**Addendum No. 3**  
**March 3, 2017**

Project: Brandon Valley Middle School Office Addition & Remodel  
Brandon, South Dakota

Project No.: 2700

Scope of this Addendum:

**R8. 01**

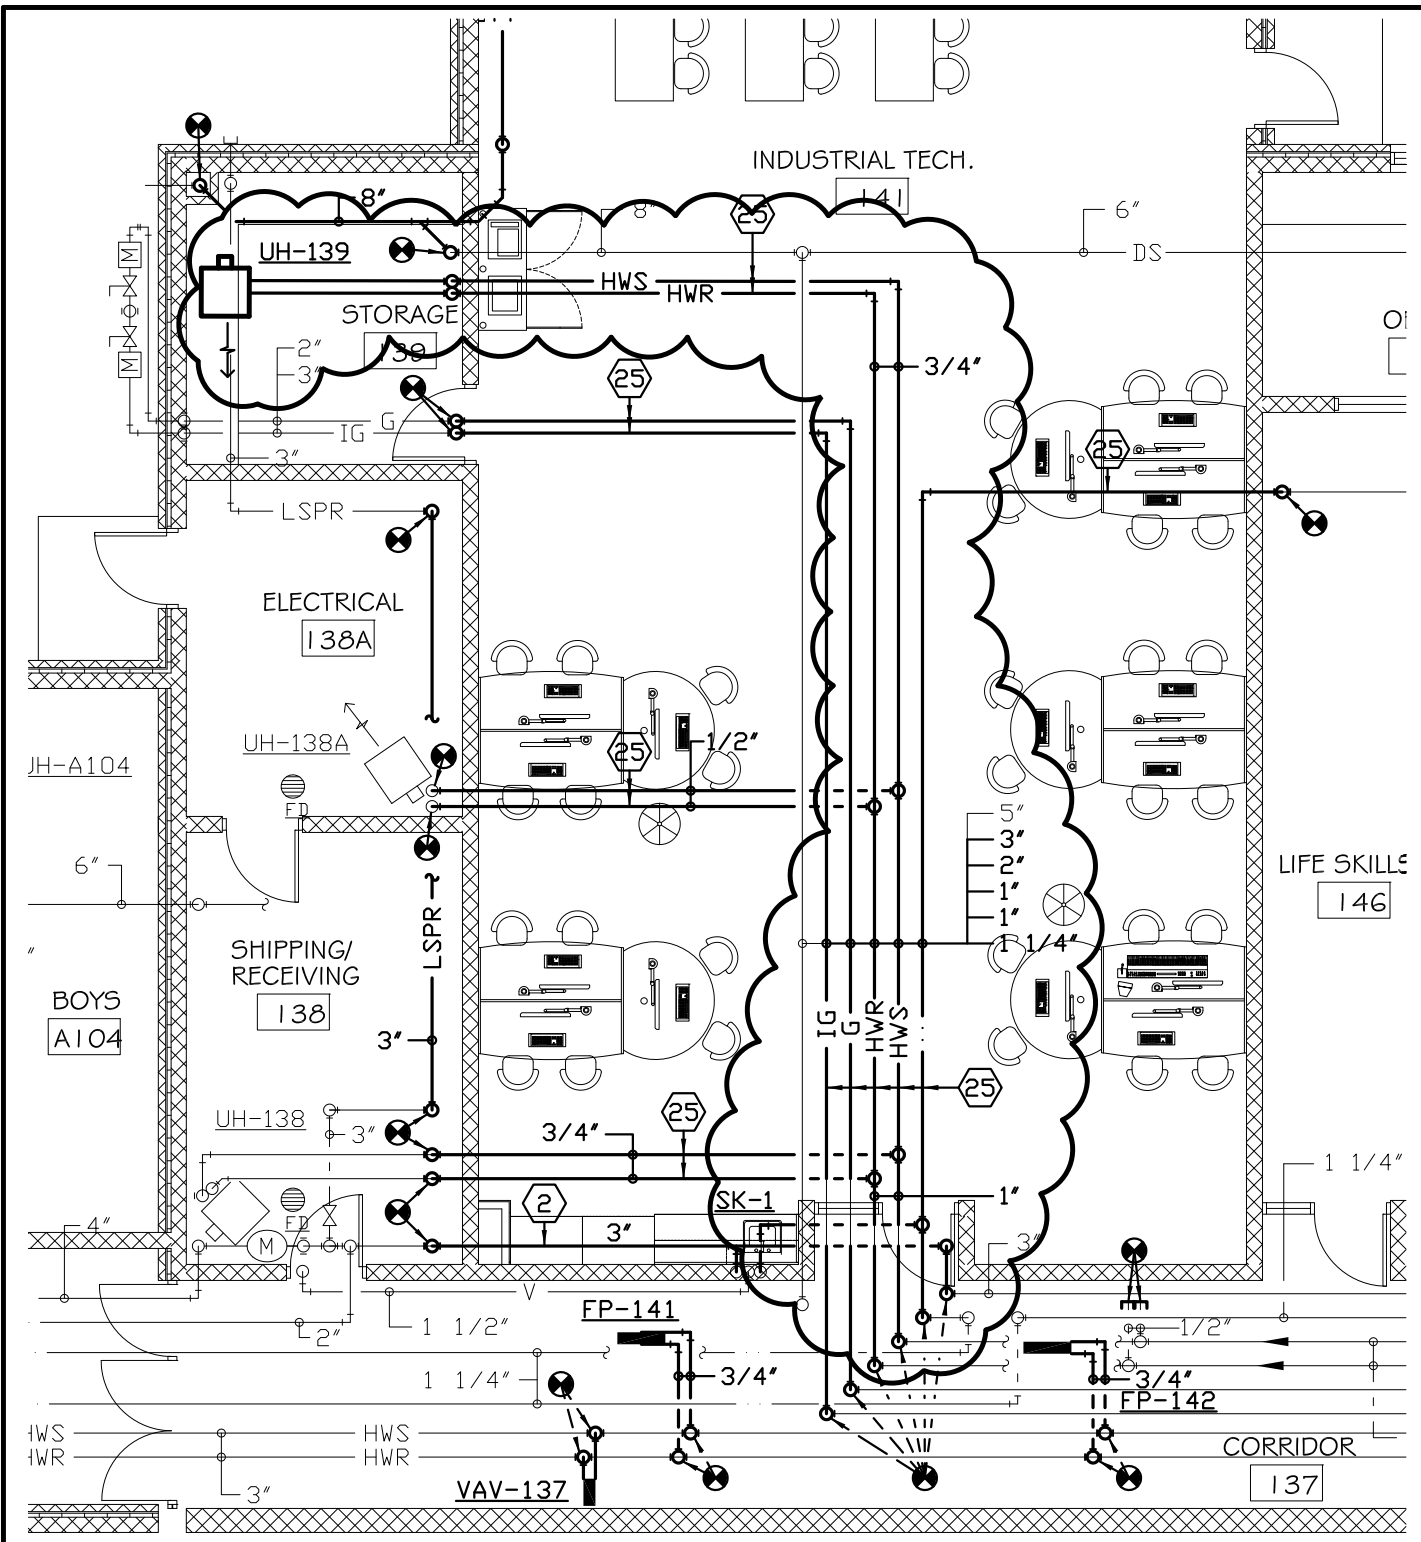
- 1) **DRAWING SHEET 8.01 – UNIT HEATER SCHEDULE**
  - a) Add unit heater UH-139. Refer to Drawing Sheet R8.01, dated 3/3/17, attached to the end of this addendum.
- 2) **DRAWING SHEET 8.20 – FLOOR PLAN AREA ‘B’ – PLUMBING & HEATING**
  - a) Add unit heater UH-139 and associated piping. Refer to Drawing Sheet R8.20, dated 3/3/17, attached to the end of this addendum.
  - b) Substitute sink designation SK-1 for the SK-3 shown. Refer to Drawing Sheet R8.20, dated 3/3/17, attached to the end of this addendum.
- 3) **DRAWING SHEET 8.30 – FLOOR PLAN AREA ‘A’ – VENTILATION & A/C**
  - a) At Files 101F, remove two (2) 10/10 transfer air ducts and one (1) G1 grille. Provide new fire damper in 8” diameter supply duct into Files 101F. Refer to Drawing Sheet R8.30, dated 3/3/17, attached to the end of this addendum.
